SuDS and Drainage Report

Wappingthorn Lodge, Horsham Road, Steyning, West Sussex BN44 3AA

Planning Ref: DC/25/I002

Rev: 2

DRAWING TITLE
IMPERMEABLE AREAS PLAN

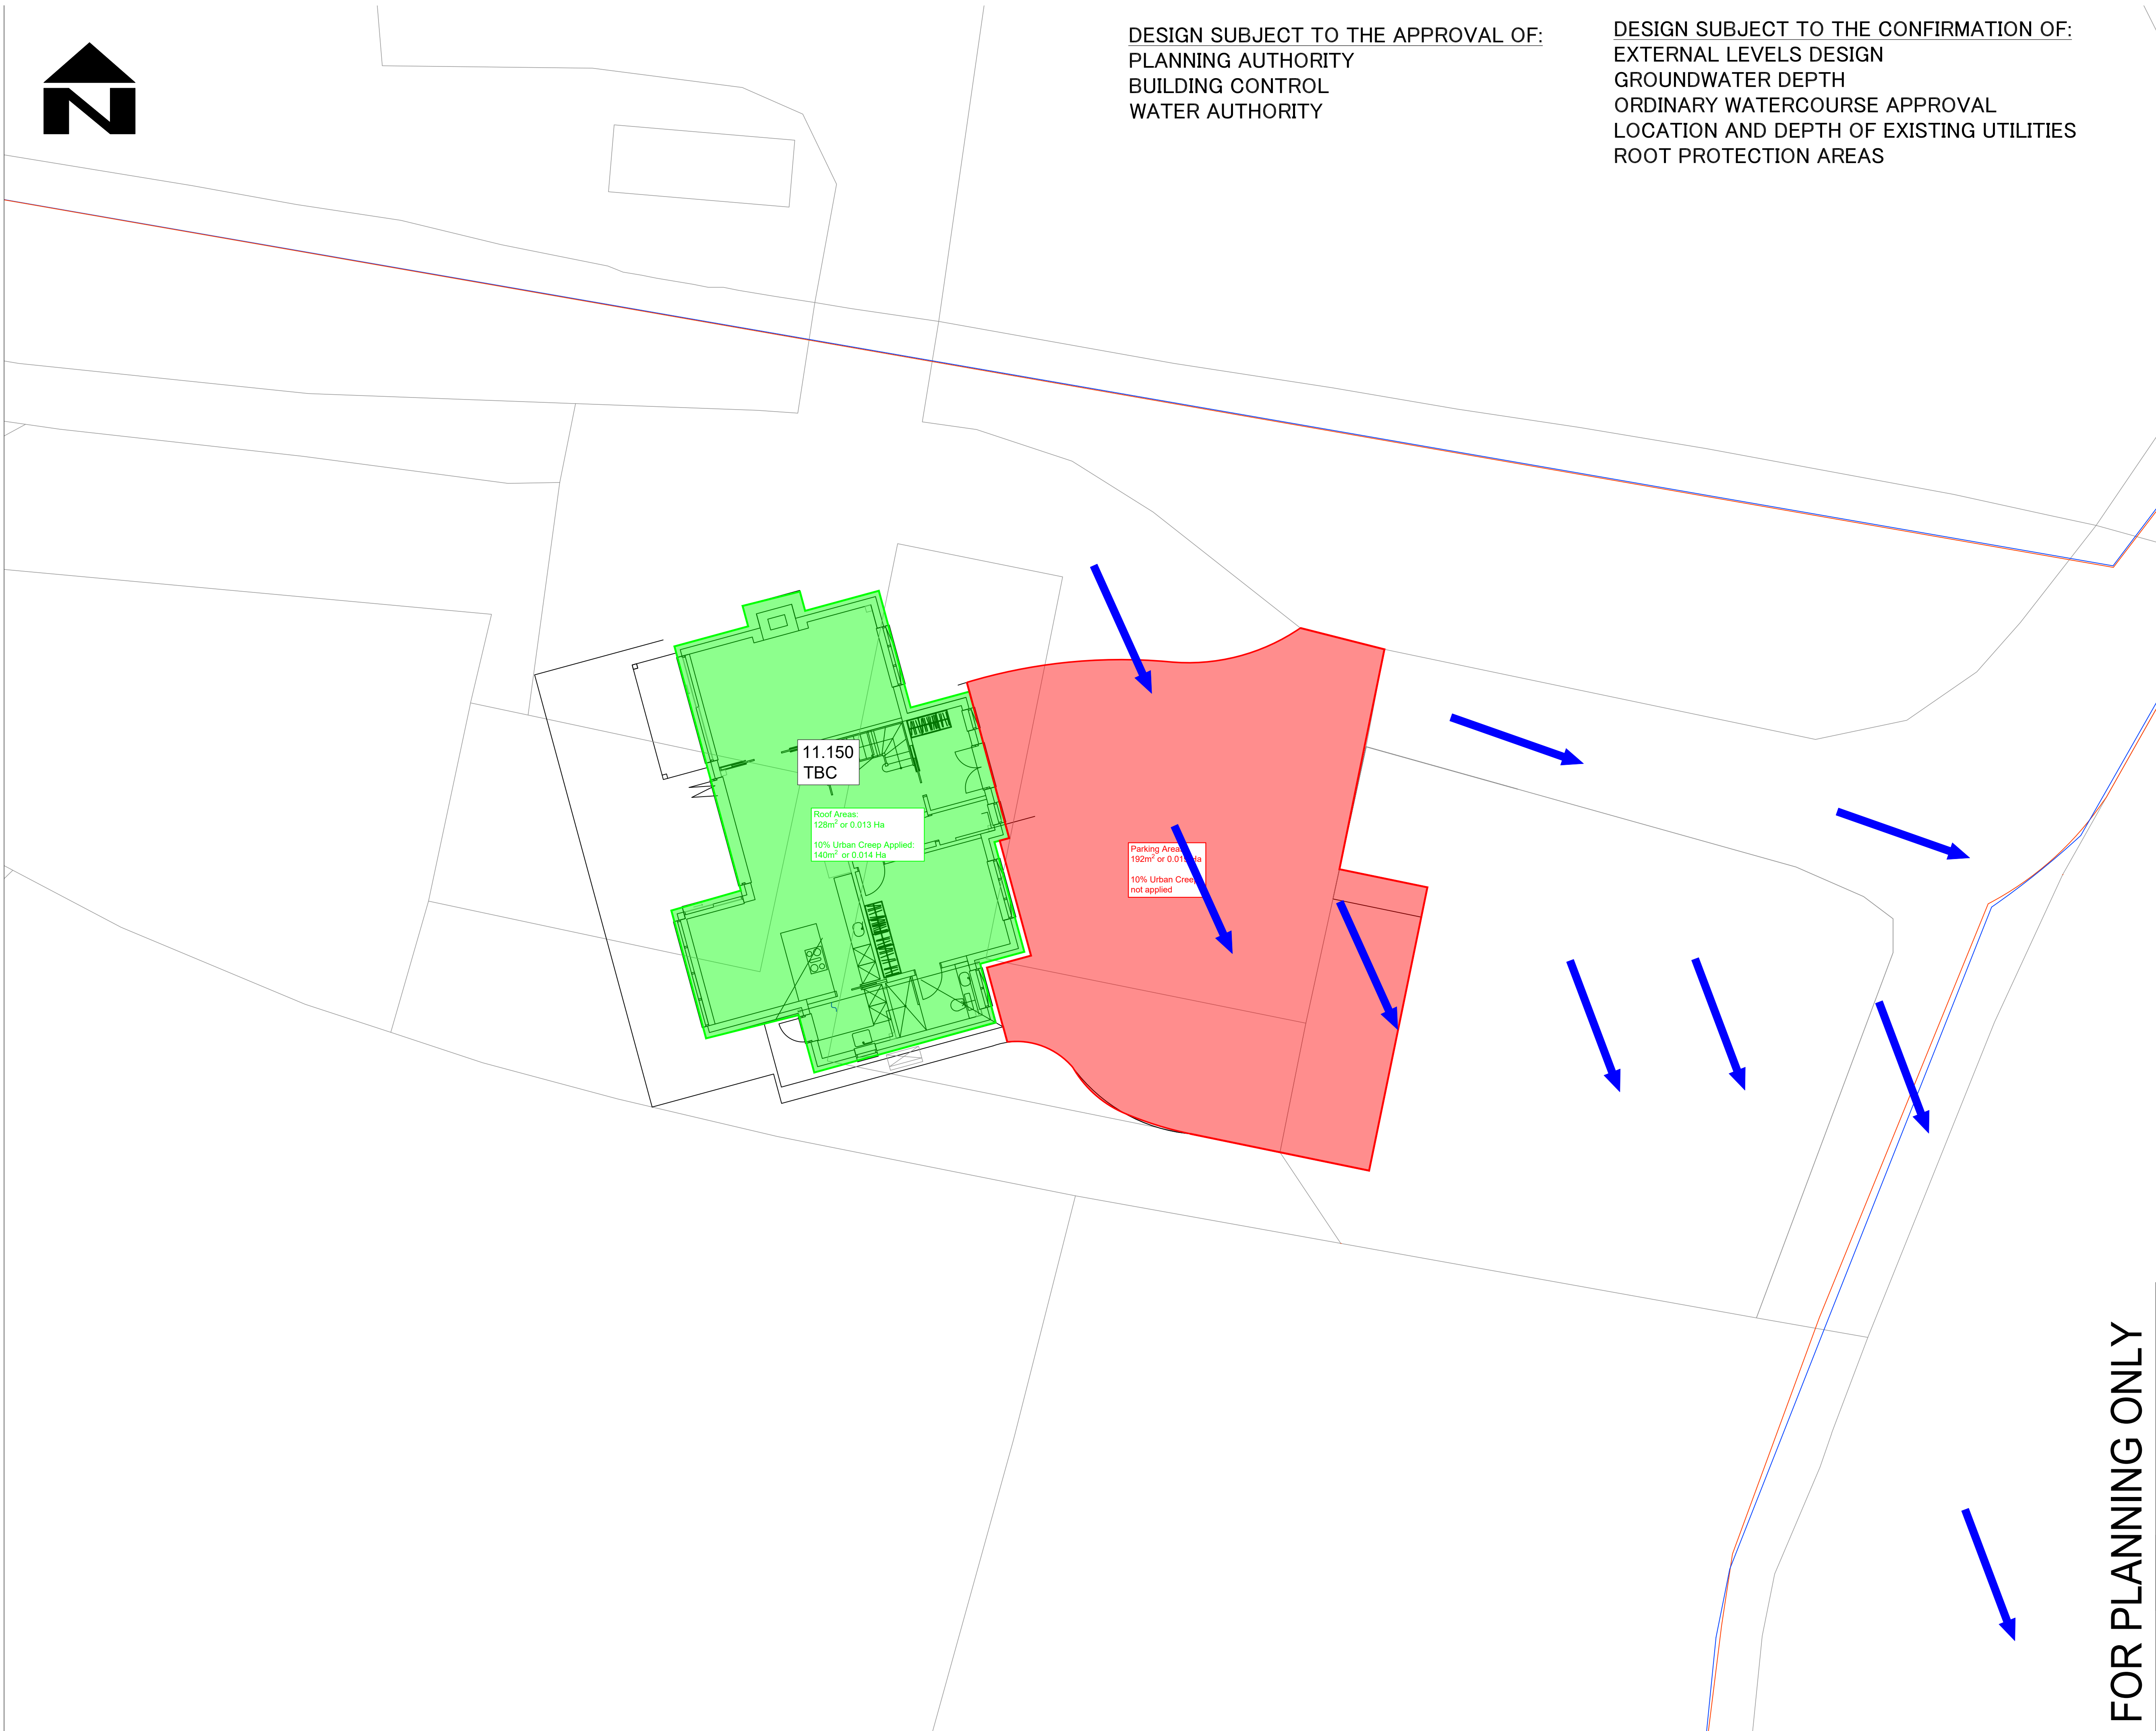
- o The 1% AEP + climate change storm event is safely contained within the site without risk to persons or property. Currently the ‘Results for 100 year +45% CC Critical Storm Duration. Lowest mass balance: 97.52%’ shows Flood Risk for the car park and S4. HDC Drainage have no concern as long as the applicant determines that water is safely contained within the site without risk to persons or property. Exceedance routes to be considered.*

2	29.07.26	ADDED EXCEEDANCE ROUTING	LH	CS	CS
P-	25.02.26	PRELIMINARY ISSUE	LH	CS	CS
REV	DATE	DESCRIPTION	BY	CHK	APP

Exceedance flow routes have been added to the impermeable areas plan. They will follow existing ground levels towards the existing pond and watercourse network as per existing overland flow. Please note that the upstand provided by kerbing will result in additional storage above ground. This will result in as much as 19.3m³ of above ground storage within the car parking area.
